LAND USE APPLICATION SUMMARY

Property Location: 3820 Emerson Avenue North
Project Name: Sojourner Truth Academy Building Addition
Prepared By: Shanna Sether, Senior City Planner, (612) 673-2307
Applicant: Mohagen Hansen Architecture
Project Contact: Jennifer Kaplan
Request: To construct a two-story, rear addition to an existing K-12 school.
Required Applications:

Conditional Use Permit	To allow for an addition to an existing K-8 school in the R2B District.
Variance	To increase the maximum impervious surface and lot coverage.
Variance	To increase the maximum floor area ratio.
Site Plan Review	For an addition to an existing K-8 school.

1 ARCH SITE PLAN
A010 1"=30'-0"

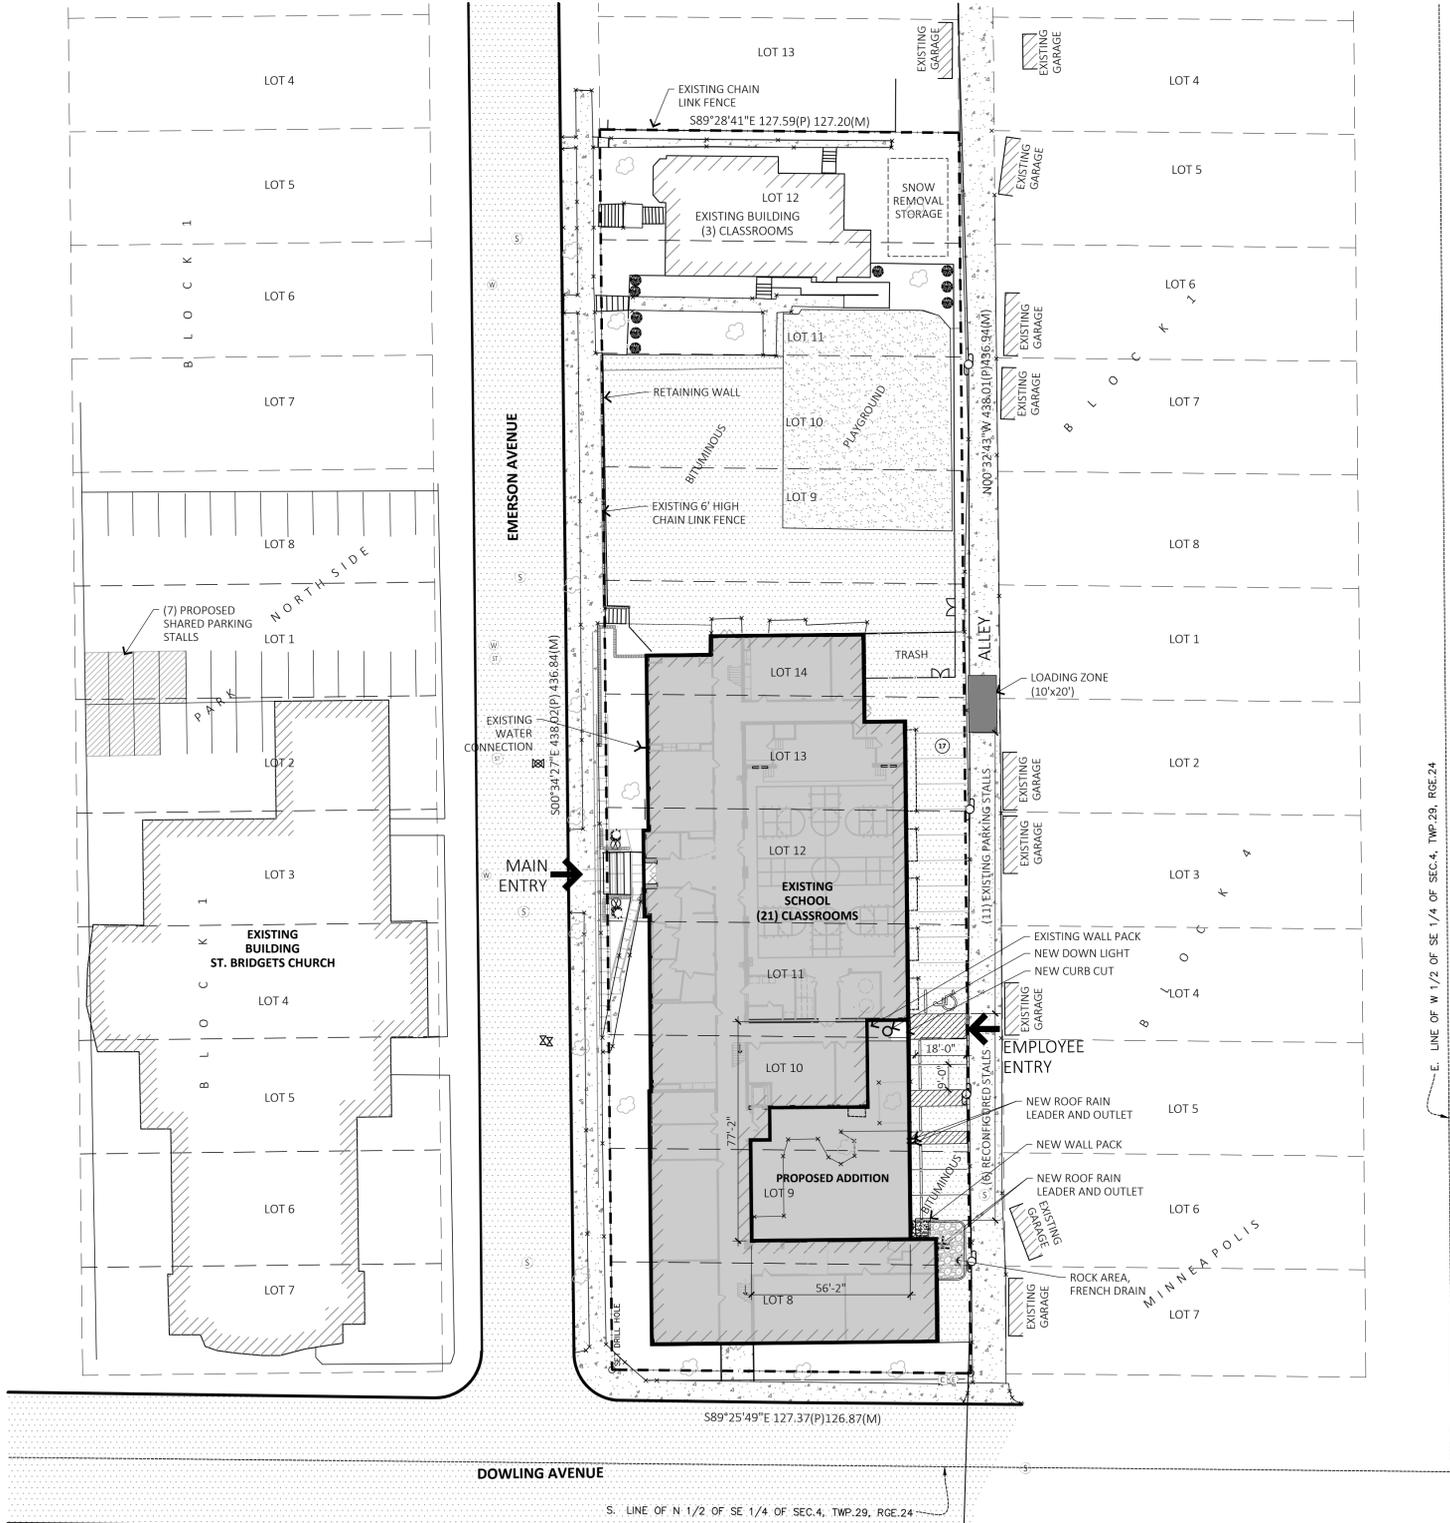
- A portion of the parking area faces Dowling Ave N; there is an on-site landscaped yard of 10.5 feet in width.
- The applicant is required to have a three-foot screen consisting of a masonry wall, fence, berm, hedge, or combination thereof that is at least 60 percent opaque, between the parking area and the public street. The applicant is requesting alternative compliance and staff is recommending that the applicant provide a screening for the parking area.

- The corners of the parking lot that are unavailable for parking or vehicular circulation are landscaped as specified for a required landscaped yard. The applicant is showing a bituminous surface between the 1956 addition and the public alley. Staff finds that this would be an appropriate area to provide additional landscaping between the public sidewalk and the parking area.

- The plan as submitted meets the requirements of the Public Works Traffic & Parking Services Division.
- Note to the Applicant: The loading zone in the alley (indicated on the site plan) shall be removed; loading is allowed in the alley by City Ordinance and it is not necessary to show it on the plans.

6. The applicant shall provide a three-foot screen consisting of a masonry wall, fence, berm, hedge, or combination thereof that is at least 60 percent opaque, between the parking area and the public street (Dowling Ave N).

1 ARCHITECTURAL LANDSCAPE PLAN
A011 51/128" = 1'-0"

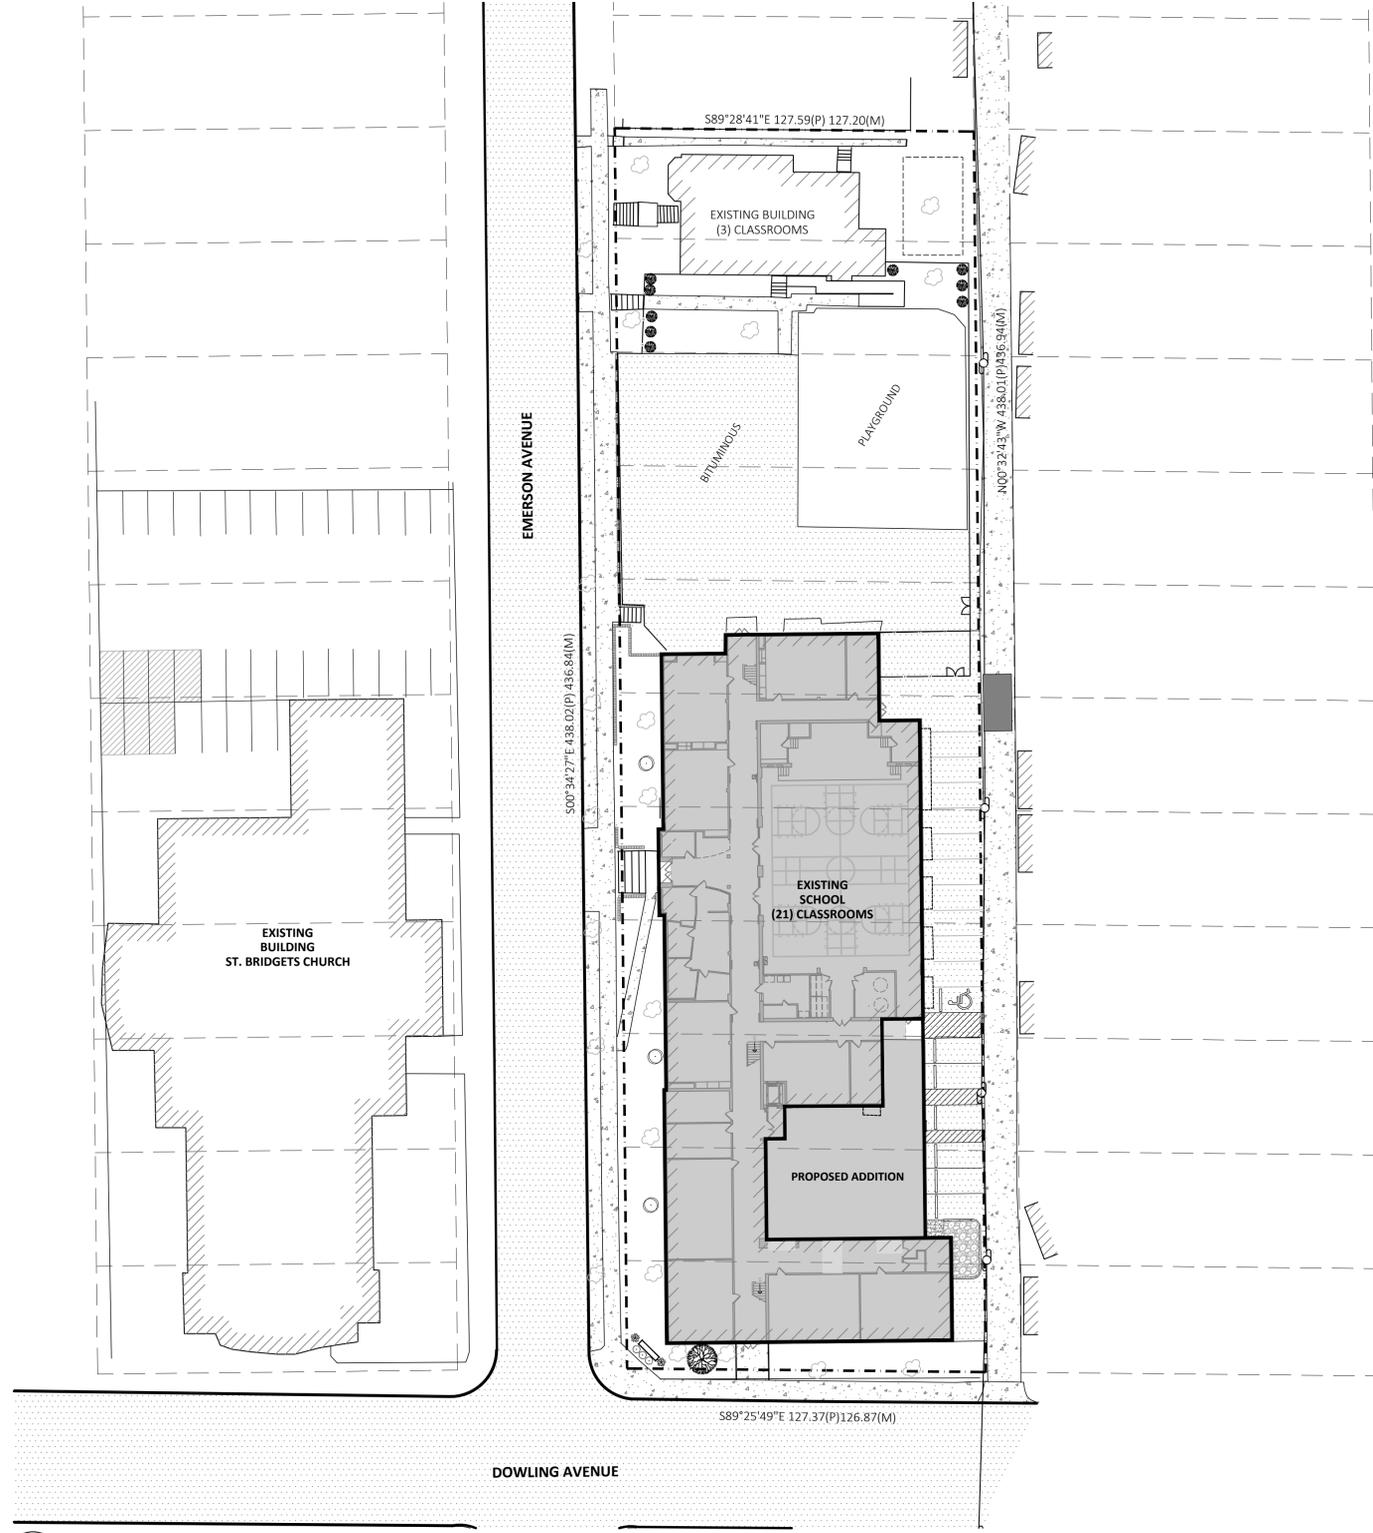
- The applicant is not proposing at least one shrub per 100 square feet of the required landscaped area, including all required landscaped yards. The shrub requirement for the site is 60 and the applicant is proposing 8 shrubs. The applicant is seeking alternative compliance. Staff is recommending that the applicant provide the required shrubs to meet the minimum requirement. There is sufficient area in the required yards along Emerson and Dowling Ave N to provide the required number of shrubs. Further, staff is recommending alternative compliance to providing the minimum number of canopy trees.

- **Required shrubs.** The applicant is not proposing at least one shrub per 100 square feet of the required landscaped area, including all required landscaped yards. The shrub requirement for the site is 60 and the applicant is proposing 8 shrubs. The applicant is seeking alternative compliance. Staff is recommending that the applicant provide the required shrubs to meet the minimum requirement. There is sufficient area in the required yards along Emerson and Dowling Ave N to provide the required number of shrubs. Further, staff is recommending alternative compliance to providing the minimum number of canopy trees.

5. The applicant shall provide a minimum of 10 canopy trees and 60 shrubs on the subject property. The plant materials, and installation and maintenance of the plant materials, shall comply with sections 530.200 and 530.210 of the zoning code.

1 EXTERIOR ELEVATION - EAST
A300 1/8" = 1'-0"

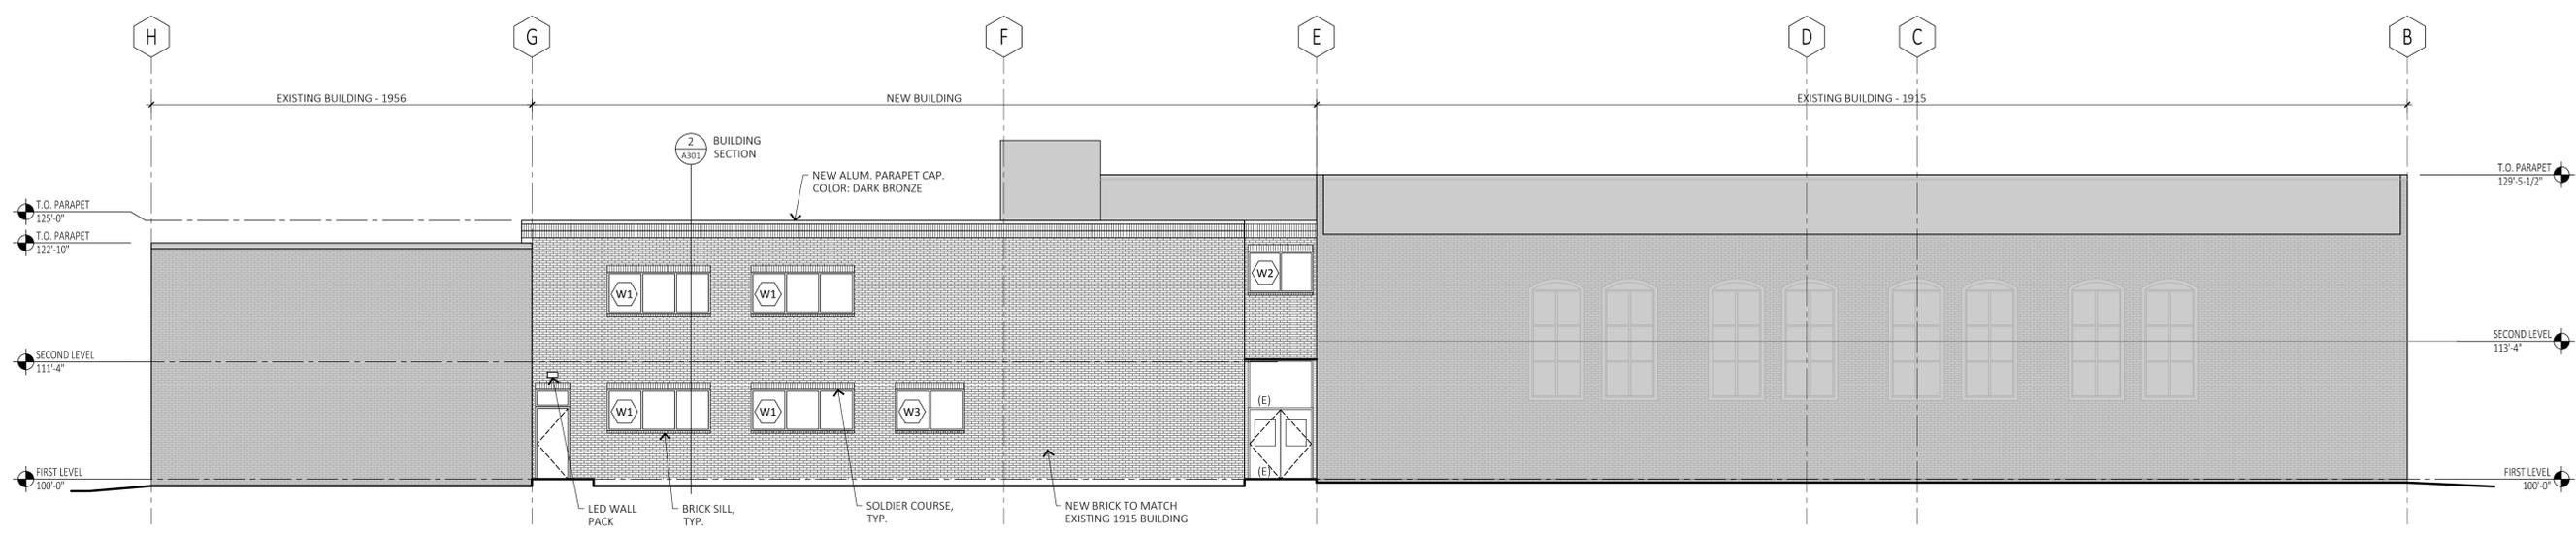
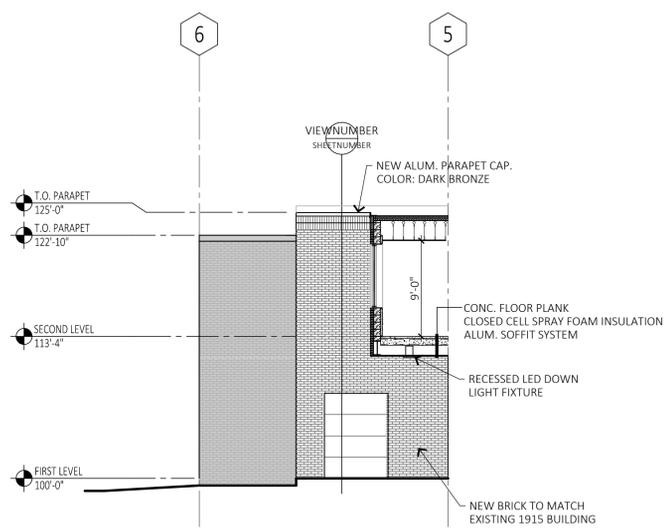
- The applicant is proposing brick to match the building’s primary exterior materials from the 1920’s building. This elevation would comply with the City’s durability standards for exterior materials (see Table 2). Please note that exterior material changes at a later date may require review by the Planning Commission and an amendment to the site plan review.
- In addition, the application is consistent with the City’s policy of allowing no more than three exterior materials per elevation, excluding windows, doors, and foundation materials.
- Plain face concrete block is not proposed along any public streets, sidewalks, or adjacent to a residence or office residence district.
- The exterior materials and appearance of the rear and side walls of the building are similar to and compatible with the front of the building.

- For nonresidential uses, the zoning code requires that no less than 30 percent of the walls on the first floor are windows with clear or lightly tinted glass with a visible light transmittance ratio of six-tenths (0.6) or higher. No less than ten percent of the walls on each floor above the first that face a public street, public sidewalk, public pathway, or on-site parking lot, shall be windows. Based on the floor plans, all proposed shelving, mechanical equipment, and other similar fixtures allow views into and out of the building between four and seven feet above the adjacent grade. The project is not meeting the minimum window percentage on the first floor and the applicant is seeking alternative compliance.
- All windows are vertical in proportion and are evenly distributed along the building walls.

- **Thirty percent windows on the first floor.** The applicant is proposing to construct a new building addition on the rear of the existing school. The proposed addition faces the on-site parking lot and 30% of the wall on the first floor is required to be windows. The applicant is proposing 18% of the walls be windows. The same area that is blank for more than 25 feet would be the best location for additional windows; however the first floor plan shows this area is for maintenance, which will not have active functions. The existing building walls on the first floor have less than 3% windows. Staff is recommending that the planning commission grant alternative compliance to this provision, recognizing the addition will be providing more active functions and windows, closer to the on-site parking area than currently exist and is moving towards conformity.

3. CPED staff shall review and approve the final site, elevation, landscaping, and lighting plans before building permits may be issued.
4. The applicant shall provide sufficient detail to avoid blank walls exceeding 25 feet, on each floor of the proposed addition, per section 530.120 (a) of the zoning code.
